UNITED STATES PATENT AND TRADEMARK OFFICE

APPLICATION NO.	FILING DATE	FIRST NAMED INVENTOR	ATTORNEY DOCKET NO.	CONFIRMATION NO.
10/811,695	03/29/2004	Mark James Kline	9595	1368

Office Action Summary

DETAILED ACTION

Fig. 2

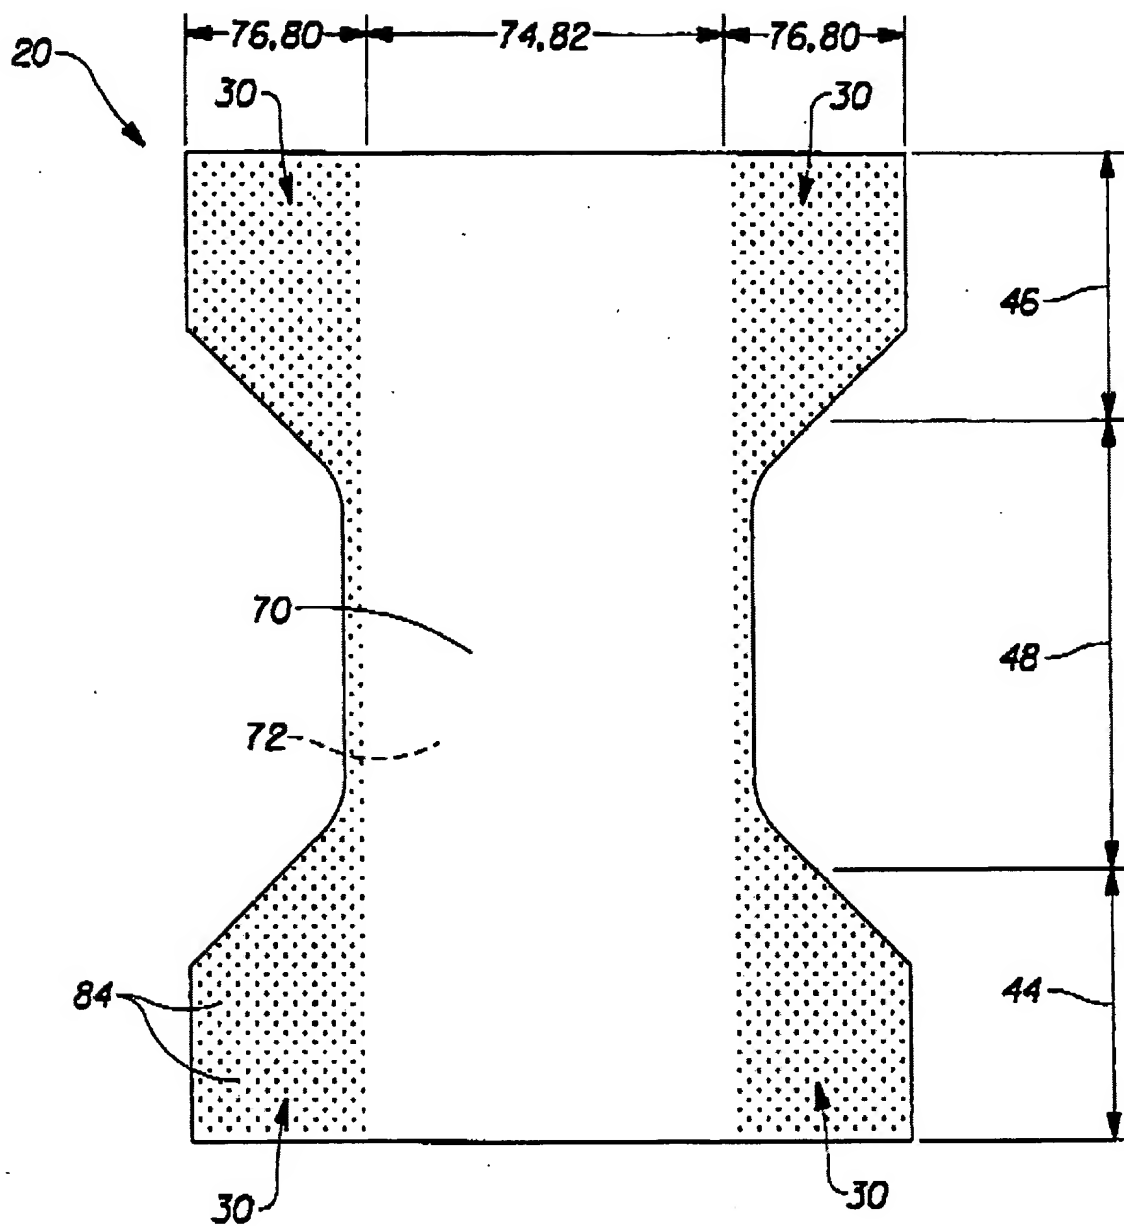
Claims 1-4, 7-9, 11, 19 and 20 rejected under 35 U.S.C. § 102(b) as being anticipated by Drobin *et al.* (US 5,571,096 A; hereinafter “Drobin”).

Drobin teaches a unitary disposable absorbent article (20), comprising:
an absorbent core (28) having a garment-facing surface and a body-facing surface;
a liquid permeable topsheet (24) positioned adjacent said body-facing surface of said absorbent core (28);

a liquid impermeable backsheet (26) positioned adjacent said garment-facing surface of said absorbent core (28); said backsheet (26) having a physical variation along at least one axis, wherein said physical variation defines a first backsheet zone (82) and a second backsheet zone (80), wherein said physical variation is a measurable difference, wherein said physical variation is as measured by a physical property selected from the group consisting of basis weight, thickness, density and tensile modulus; at least one elastomeric element (34) having at least one primary direction of stretch, said elastomeric element (34) at least partially overlapping and joined to said second backsheet zone (80)(col. 13, lines 1-8, incorporating by reference U.S. Pat. No. 4,515,595 to Kievet *et al.*, which discloses an elastomeric element which extends across the entire transverse width of the waist portions);

a first stretch region (44) having lateral stretch; and

a second stretch region (46) having lateral stretch; wherein said first stretch region is capable of co-elongating with said second stretch region (see figure 2, *infra*). The limitation concerning the co-stretchability of the elastic elements is functional. An apparatus claim must be structurally distinguishable over the prior art. MPEP § 2114.

Drobin teaches that the apertures may be formed by cutting holes out of a film without forming cones, such that the apertures will have a caliper the same as the film thickness, which necessarily means that some material will be removed from the film leaving it with a decreased density and basis weight (col. 9, lines 28-30). The result is that the unperforated portion (82) of the backsheet (26) has a greater basis weight and density than the perforated portions (80).

Applicants assert that Dobrin’s zones (80, 82) vary only in vapor permeability, not basis weight or density. This argument is not persuasive because Dobrin teaches that the apertures may be formed by cutting holes out of a film without forming cones, such that the apertures will have a caliper the same as the film thickness, which necessarily means that some material will be removed from the film leaving it with a decreased density and basis weight (col. 9, lines 28-30). Additionally, Dobrin at col. 9, line 41, incorporates by reference Radel *et al.* U.S. Pat. No. 4,342,314 which at fig. 12 clearly shows a film with apertures that result in a lower basis weight film than a film without such apertures. The result is that in the device of Dobrin, the unperforated portion (82) of the backsheet (26) has a greater basis weight and density than the perforated portions (80).

Fig. 1

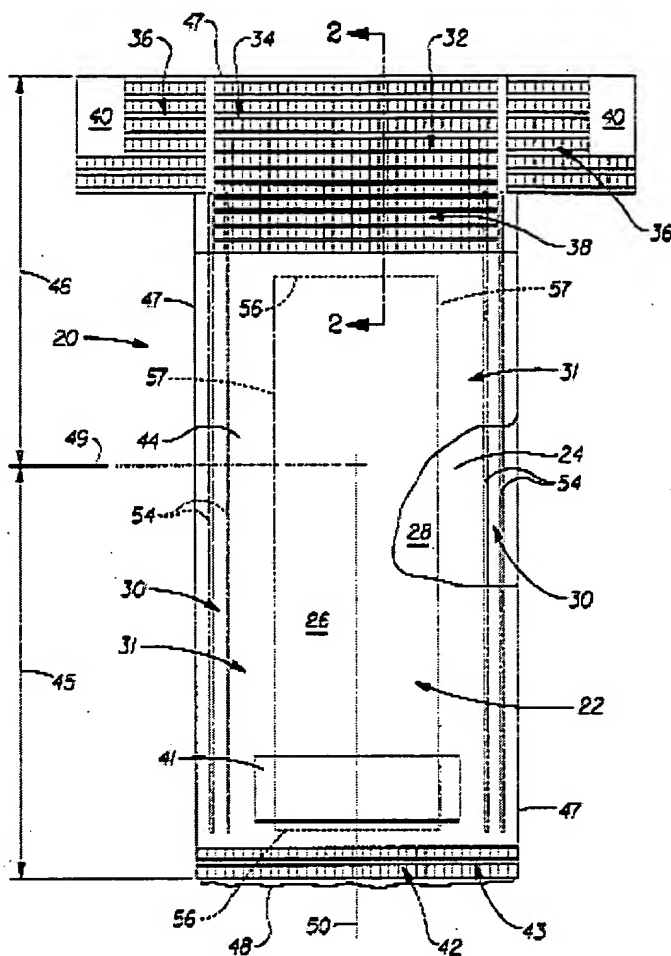
Claims 1, 5, 6, 10, 14 and 16-18 are rejected under 35 U.S.C. § 102(b) as being anticipated by Roe *et al.* (US 2002/0128617 A1; hereinafter "Roe").

a liquid impermeable backsheet (26) positioned adjacent said garment-facing surface of said absorbent core (28); said backsheet (26) having a physical variation along at least one axis, wherein said physical variation defines a first backsheet zone (34) and a second backsheet zone (crotch region), wherein said physical variation is a measurable difference, wherein said physical variation is as measured by a physical property selected from the group consisting of basis weight, thickness, density and tensile modulus; at least one elastomeric element (54) having at least one primary direction of stretch, said elastomeric element (54) at least partially overlapping and joined to said second backsheet zone;

a first stretch region (34) having lateral stretch; and

a second stretch region (43) having lateral stretch; wherein said first stretch region is capable of co-elongating with said second stretch region (see figure 1, *infra*).

Zones (32) and the backsheet at the central crotch region differ in their tensile modulus.

Applicants assert that Roe does not teach zones with a different tensile modulus. This argument is not persuasive because Roe expressly teaches that topsheet/backsheet zones (34) and (43) have different stretch and extension properties that the rest of the topsheet/backsheet (paragraphs 0009 and 0046). Regarding the definition of “tensile modulus”, it is interpreted herein as meaning: The measure of the initial resistance of a material to longitudinal stretching. See e.g., *Materials by Design: Elastic Modulus*, Cornell University, 1996. Applicants have not specifically defined “tensile modulus” to have a meaning other than this, as such, the claims are given their broadest reasonable interpretation. MPEP § 2111.
